Before the Hearings Commissioners at Christchurch City Council

in the matter of: an application by Ryman Healthcare Limited for
resource consent to establish and operate a
comprehensive care retirement village at 100-104 Park
Terrace and 20 Dorset Street, and 78 Park Terrace,
Christchurch

Statement of evidence of **Andrew Davies Burns** on behalf of
Ryman Healthcare Limited

Dated: 6 January 2021

Figure 11 - Ground level interface of Building B07

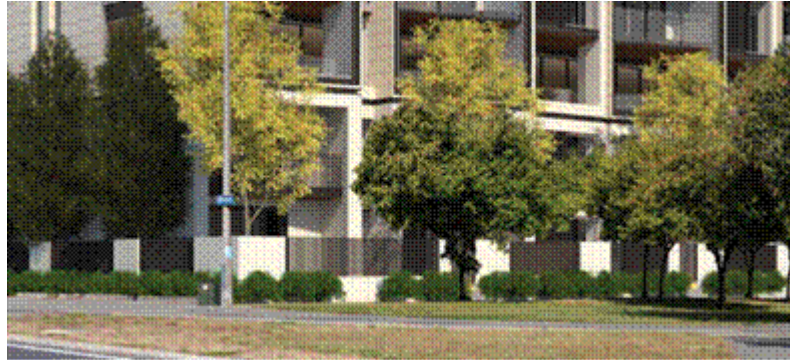
the provision of patio courtyards as an interface. These courtyards have direct entry into the units and pedestrian gate connections with the street, and with views onto the Avon, are likely to be attractive spaces to occupy. In my opinion, good engagement with Park Terrace will result, provided the pool fencing is kept relatively clear of dense shrub planting as proposed.

Figure 12 - Salisbury Street – Building B07 frontage

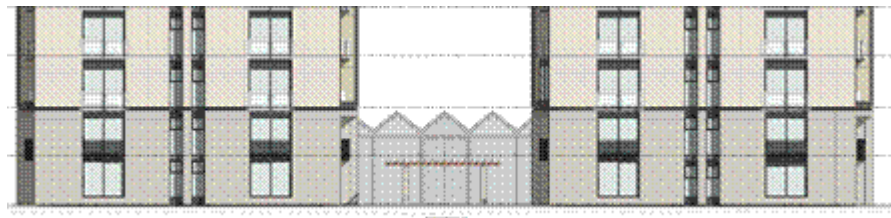
- 79 The UDLVA considers that Building B07 creates a “*clear visual break... with views to the low-level, visually light entry pavilion beyond*”. Ms Skidmore explains how the glazing on the Salisbury Street facades was amended to respond to Urban Design Panel feedback. I agree that the larger windows will reduce the visual dominance of sheer walls and visual connection with the street (see Figure 12 below). In addition, the proposed trees coincide with solid fence elements, and pool fencing coincides with windows, to ensure visual engagement with the street. While no direct entrances to ground level units are provided on the Salisbury Street interface, as the units’ primary internal corridor entrances and secondary patio doors make further entry onto Salisbury Street unnecessary. Although providing entrances onto Salisbury Street would result in better engagement with the street, as sought by the District Plan, I consider that, in the round, the B07 Salisbury Street façades provide a good level of engagement with the street. In my opinion, the different design responses on the Park Terrace and Salisbury Street interfaces are also suitable to the Park Terrace / Salisbury Street spatial hierarchy.

Figure 15 - B08 north elevation and B07 SE corner

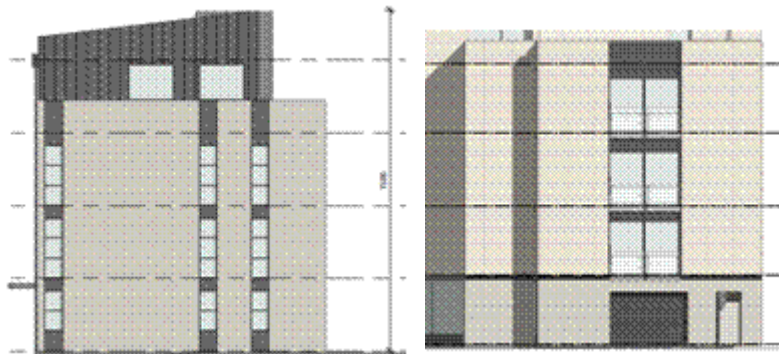
- 90 Building B08 occupies a rather discrete leg to the Peterborough Site. It steps down to 3 storeys at the street interface and therefore has a relatively benign presence along Peterborough Street. It also has a fairly minor presence on the internal accessway that runs around Building B07. Building B08 performs a function terminating views into the Peterborough Site from Salisbury Street, although I consider it presents a relatively blank built outcome and therefore doesn't acknowledge this built form role (see Figure 15 below), but not to such an extent that affects the performance of the Peterborough Site as a whole.

Figure 17 – Building B02 northern boundary – built form standard exceedances

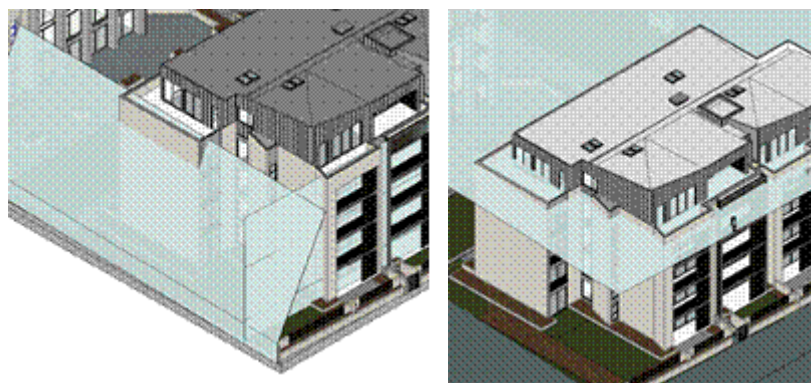
- 97 Building B02 is 5 levels, and breaches the height and recession plane standards as shown in Figure 17 below.
- 98 Part of the proposed Level 5 balcony breaches the recession plane standard and users of this outdoor space will be able to look north towards 108 Park Terrace. Building B02 has limited windows facing north towards 108 Park Terrace. The windows from the living spaces of the top-level apartments will have views north towards 108 Park Terrace. 108 Park Terrace is set back 8.789m

- 100 In terms of visual dominance / outlook effects on 108 Park Terrace, I agree with the UDLVA that this neighbour has been designed to "*orient away from the Site*" (Figure 16) and looks towards the park. Views towards Building B02 will occur from the south façade of 108 Park Terrace, however the outlook is primarily from bedrooms at levels 1-5 and will be onto forms some 13m-18m away and generally compliant with the built form standards. The penthouse level of 108 Park Terrace is set back some 4.7m and given the top-level setback of Building B02 and the expansive views towards the Park, I do not consider the Proposed Village to negatively affect the visual amenity of this neighbour.

Figure 18 - B01 northern edge

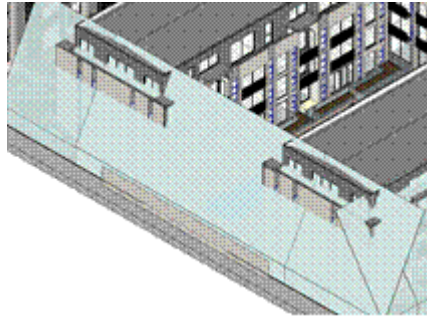
- 101 Building B01 adjoins these neighbouring properties. Figure 18 below shows the recession plane standard infringements in this

location, which bring windows and balconies closer to the boundary.

- 102 I agree with the UDLVA that the Proposed Village will not result in adverse shading effects on these neighbours. This outcome is due to Building B01 being located to the south of the Dorset Street neighbours as confirmed by the shading studies (A0-200).

Figure 21 – Southern elevation of the consented stables building and cross-section through the stables

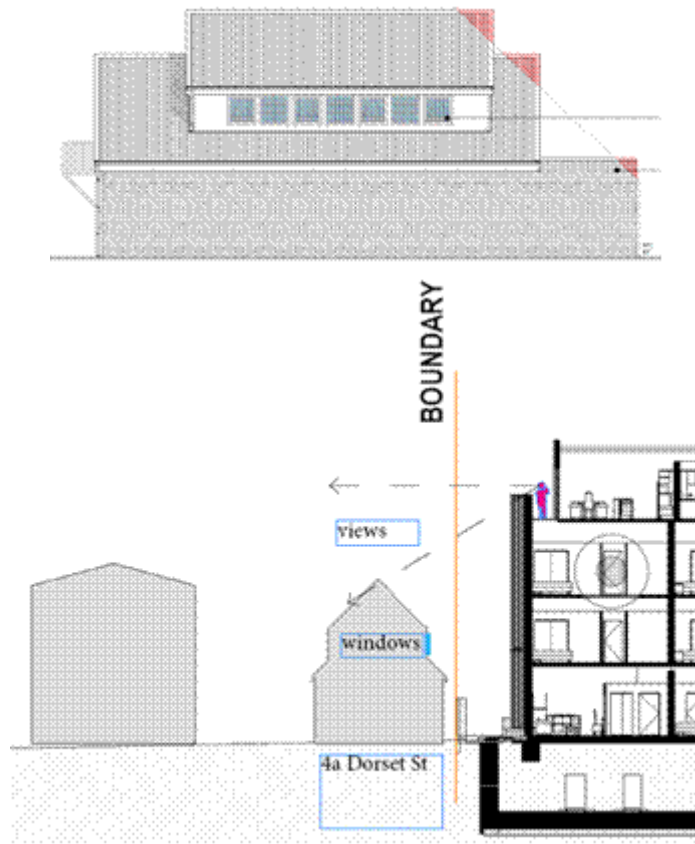
- 108 I understand the reconstruction of the former 'stables' building, comprising garaging and a 1-bed unit above, is consented. As noted in the UDLVA, the 1-bed unit will be located 600mm from the boundary, has opaque glazing facing the Site and is otherwise built into the roof raking away from the Site (see Figure 21 below).

- 109 I consider the relatively blank and benign northern façade of Building B01, with its louvred narrow windows, will mitigate overlooking effects on this property. I have confirmed using the WAM cross-section (Figure 21 below) that views from the top-level of Building B01 will not be directed onto the stables windows (which I note are opaque glass). The living room setback breach of Building B01 brings the living room northern walls 750mm closer to the boundary than otherwise anticipated but the opaque glazing of the stables windows will mitigate perception of any increased visual dominance effects. I therefore conclude any visual effects on 4A Dorset Street will be low as per the UDLVA. Were views through the windows to be possible, the same extent of wall area from Building B01 would be present in the view, albeit slightly closer and therefore I would consider any overall effect to be slight.

Figure 23 – Building B03 recession plane and height plane protrusion, Building B03 west elevation facing No. 18, and Building B01 recession plane protrusions.

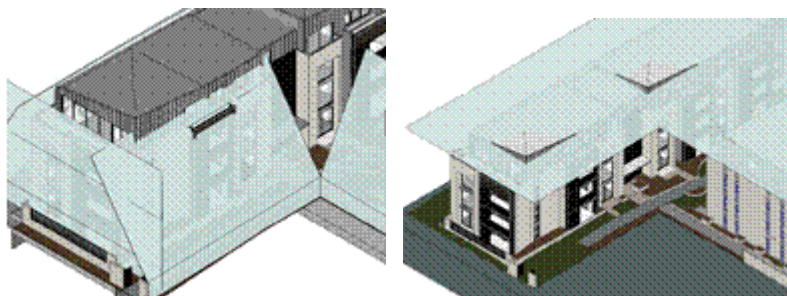
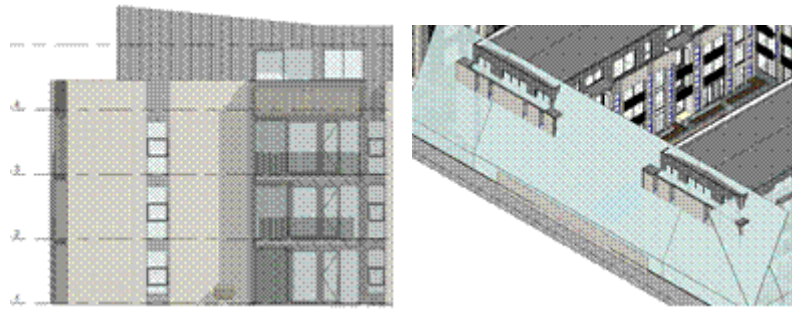
- 112 Buildings B01 and B03 interface with the boundary of this property. The infringements of the height and recession plane standards in this location are shown in Figure 23. Any views from Building B01's upper level windows and balcony will be onto blank wall, carparking or, possibly, indirect angled views towards this property. The majority of the northern end of Building B03 facing this property is solid wall with small bedroom windows, and the small area of recession plane infringement includes rain screen only (no windows). I consider visual effects on this neighbour will be very low in the context of development enabled by the zone provisions.

Figure 26 - Building B03 eastern edge

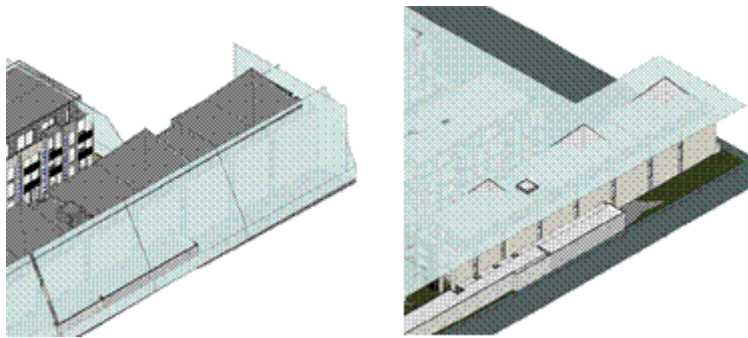
- 120 Figure 26 shows the recession plane and height standard infringements at the interface with the hotel. I agree with the UDLVA that these “*very small projections... through the HRB envelope... will not be readily perceptible and will not adversely affect amenity*”. I also agree with the UDLVA that the limited glazing of Building B03 and the setback between B03 and the hotel will “*ensure that overlooking and unacceptable visual dominance is avoided*”.

Figure 28 - Building B01 southern edge recession plane and height breaches

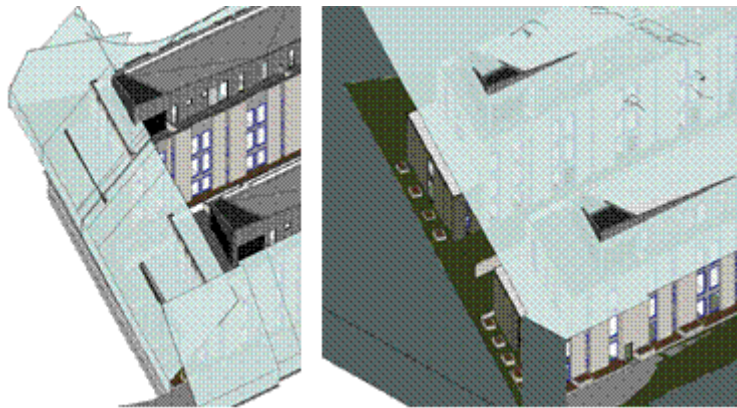
- 124 Figure 28 shows the Building B01 breaches of the recession plane and height standards along the southern boundary with these properties. The breaches comprise roof parapet edges and feature roof elements only. No occupiable balcony spaces exist at this boundary.

Figure 33 - built form standard infringements for Buildings B07 and B08

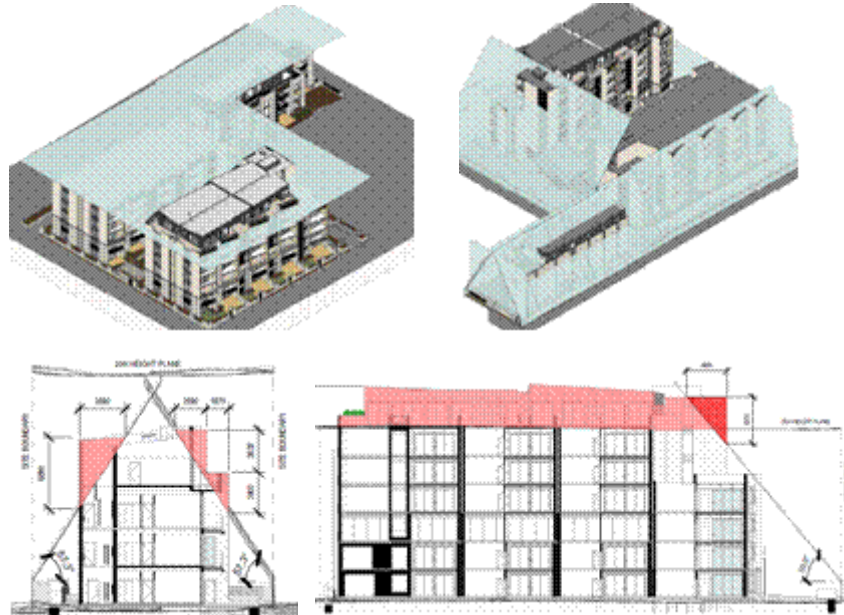
- 136 The UDLVA notes that the Proposed Village has been designed to respond to the qualities of the Peterborough Site and its surrounding context at a "*finer grain*" rather than simply relying on the increased height standard (20m). The assessment drawings provided by WAM (Figure 33 below shows the Building B07 height

standard breach and the Building B07 and B08 recession plane breaches. I agree that the general approach of locating greater height (up to seven storeys) at the Park Terrace frontage and reducing the height to four and five stories towards the eastern and southern boundaries of the Site is a more nuanced design approach that helps to address amenity effects on neighbours.

Figure 36A – Building B08 recession plane breach

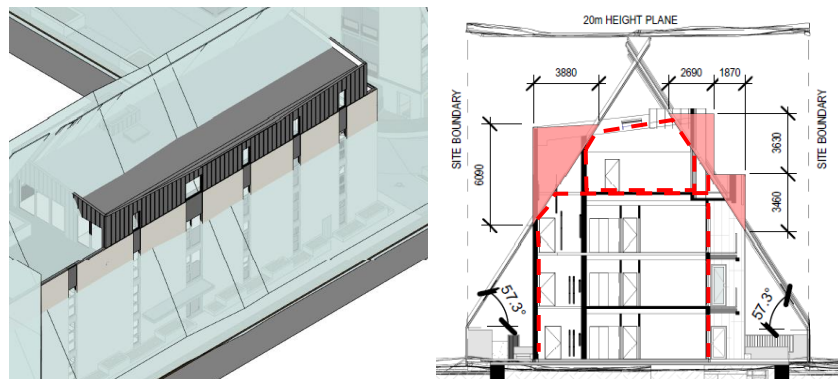
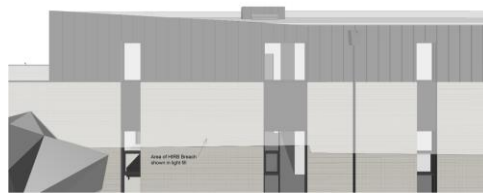
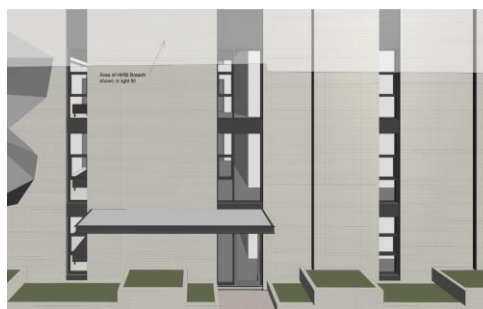
- 142 The visual change can be seen in the images below. The built form exceedances for Building B08 result in a greater amount of upper level façade that will be in view from this neighbour. However, the recession planes would still allow the top-level of Building B08 to occur albeit set further back away from number 15 by 1.67m-2.89m. The units at levels 4 and 5 of No. 15 (positions 1a and 1b) would still experience an outlook onto the top two levels of Building B08 though with reduced visual dominance due to the additional setback (see cross-section below). Therefore, while the breach brings the building façade further forward, the change to the total extent of building in the field of view is relatively slight. I consider the overall visual effect to be low-moderate or minor adverse.

Figure 38 – Building B07 southern edge recession plane and height standard infringements

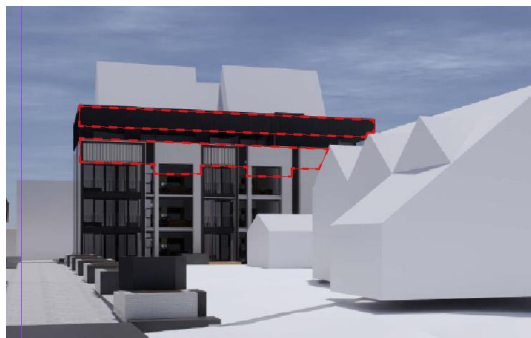
- 146 The UDLVA states that the stepping down of part of the west wing of Building B07 from seven to four storeys and the intervening planting creates a “sensitive transition” with this property. I agree that this reduced height (and conformity with recession planes) reduces adverse amenity effects on this property. The mature tree planting along the boundary and proposed planting will also help to interrupt views from 76 Park Terrace towards the southern end of Building B07.
- 147 The stair core however does not step down and presents a large, relatively blank upper-level façade. This facade will most likely be in view from the northern living, bedroom and open spaces of this property. The UDLVA notes as providing “*some increased visual dominance*” but overall considers this adverse effect is “*minor*”. I agree that increased visual dominance from the stair core is likely

to occur and further articulation and colour change could be considered in mitigation. The intervening tree planting (existing and proposed) will have some effect on interrupting views north onto this stair core. Overall, I consider visual dominance will have a low-moderate level or minor adverse effect on this property. I understand Ryman intends to propose a darker and more recessive colour for the lift shaft area, and I support that change.

Figure 39 – Building B08 recession plane and height standard infringements (top image supplied by WAM, with my red dashing added to show approximate extent of infringement)

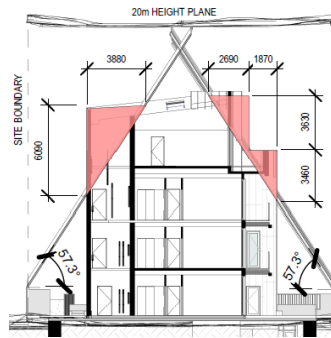
- 150 Figure 39 below shows those parts of the western facade of B08 that exceed the built form standards. I consider those infringements will result in increased visual dominance for No. 76. I observe that the extent of the breach is circa one-third of the amount of façade in this view. Were the development to comply with the recession planes it would result in a narrower top level set further back from the site's western (and eastern) boundaries thereby having less visual impact, but nevertheless still in view. Other factors worth noting are the presence of 15 Peterborough Street behind that already establishes a built skyline in this view, and the height compliance of B08 (well under the 20m limit). Therefore, I consider visual effects to be minor adverse.
